# Proposed Drawing Changes

## Marked Versions of Figs. 1 and 2

Proposed Drawing Changes  
MARKED VERSIONS OF  
Figs. 3 and 4

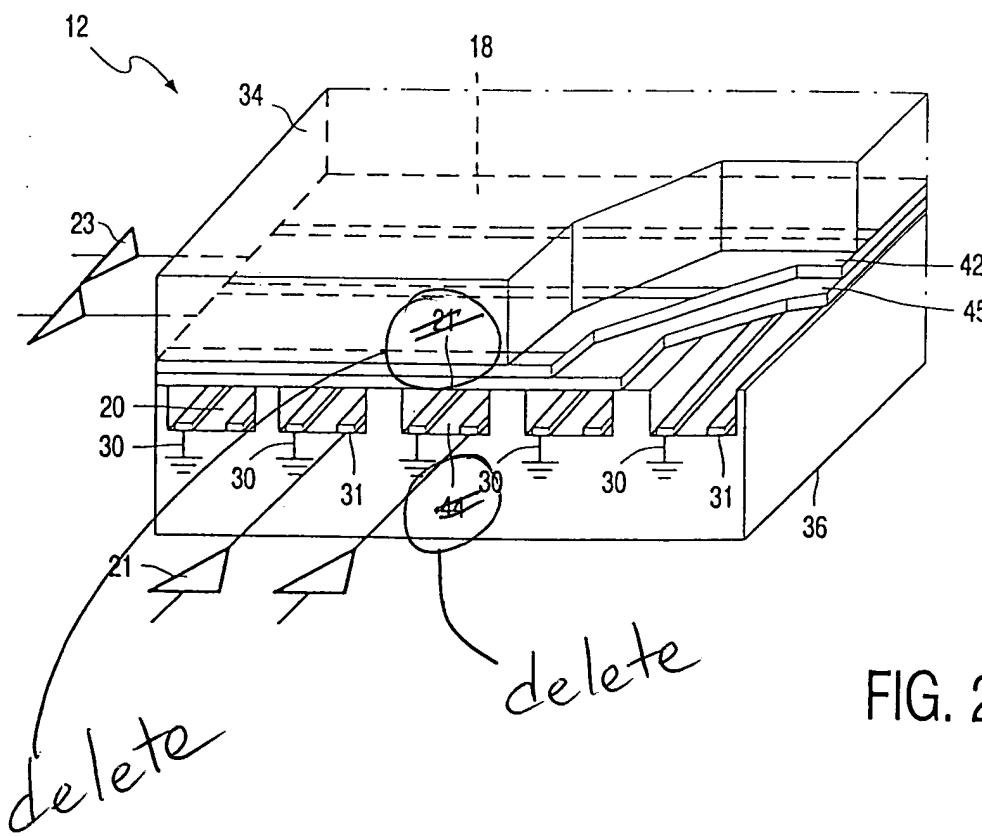
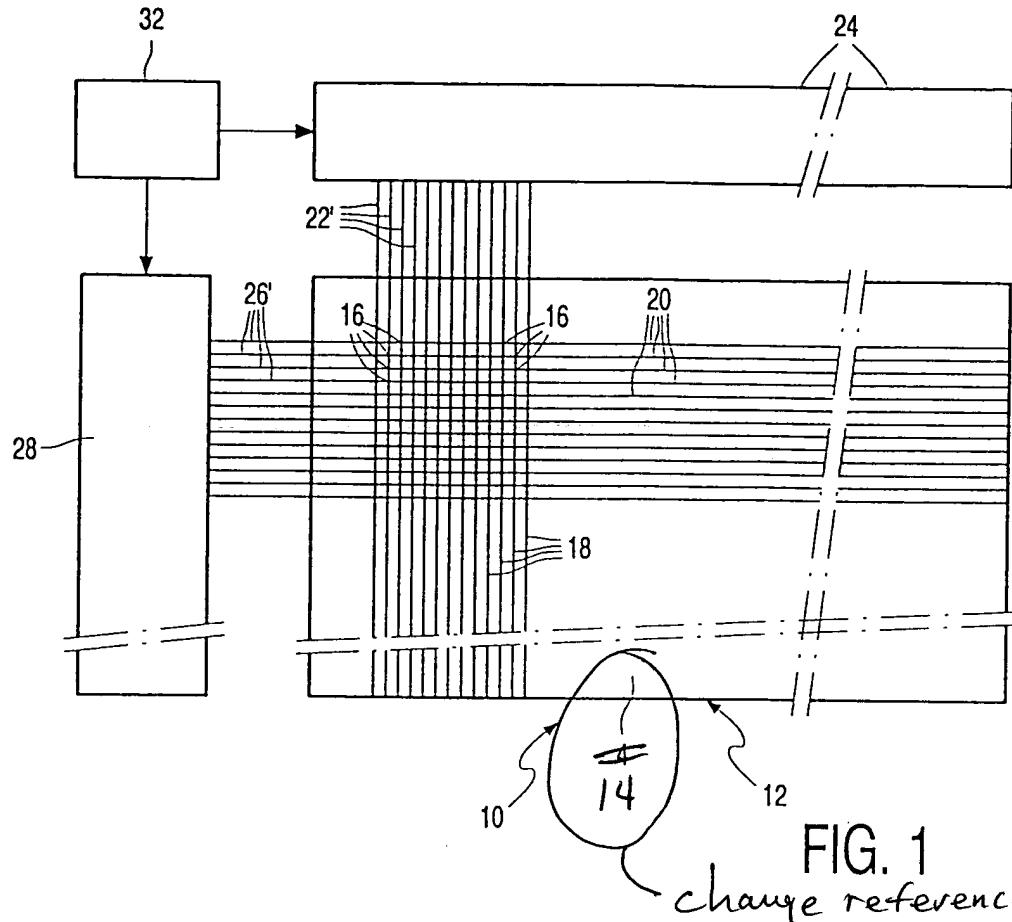
1. In response to the objections to the drawings, copies of Figs. 1,2, 3 and 4 are enclosed, having proposed changes thereto in handwritten changes in red-ink. Upon approval of these changes formal drawings including these changes will be provided.

FIG. 3

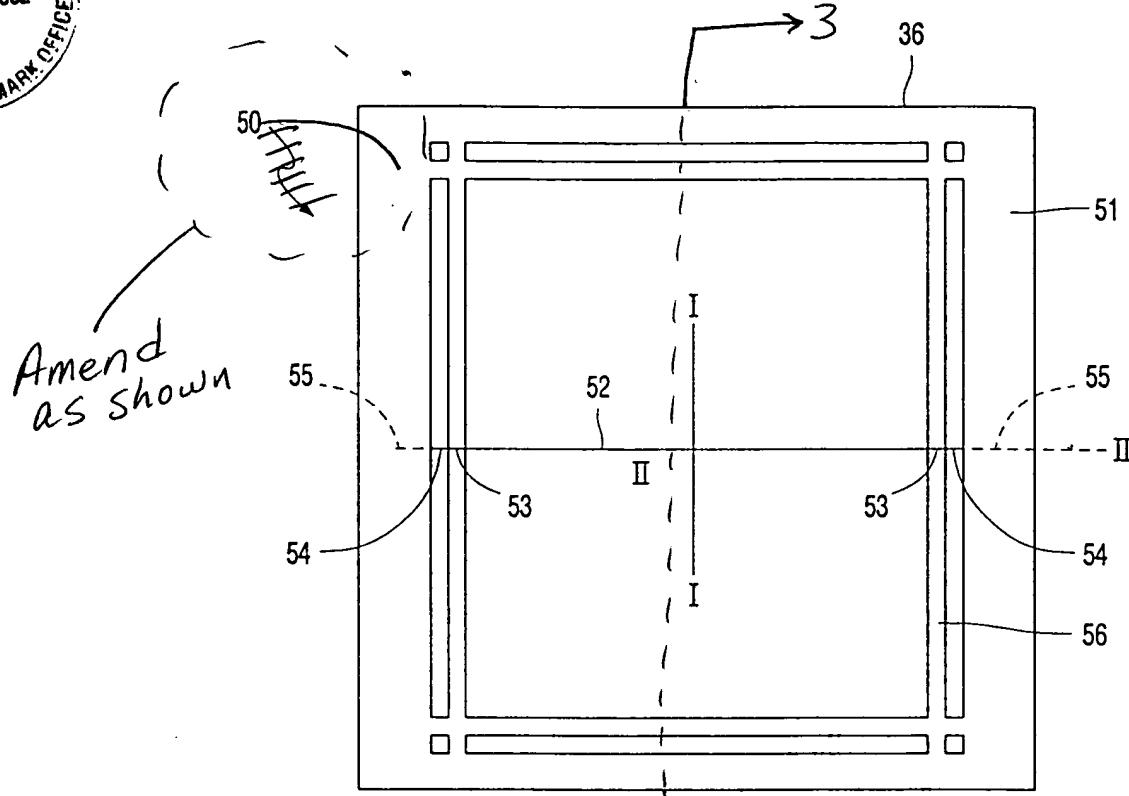
delete  
this  
reference  
numeral.

FIG. 4

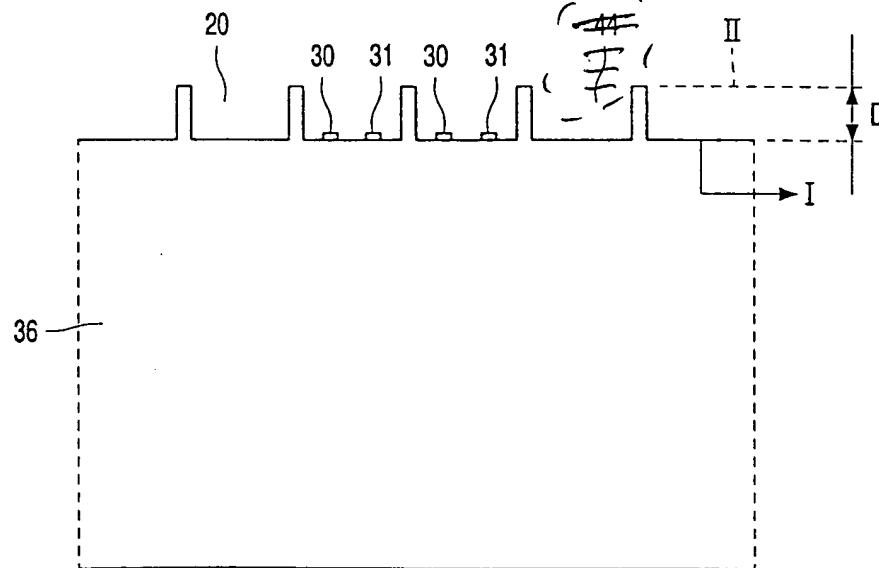
2. Please replace the paragraph that begins on page 5, line 22 (with the words "Figure 4 shows..." with the following paragraph:

Figure 4 shows a cross-sectional view taken along line 3-3 in Figure 3. The bottom of the channels 20 filled with ionizable gas extend in a bottom plane I, the tops extend in a top plane II, these planes defining the depth D of the channels 20. Each channel 20 in plate 36 is provided with electrodes 30 and 31. The depth D is typically 0.15-0.25 mm, but is not limited thereto.
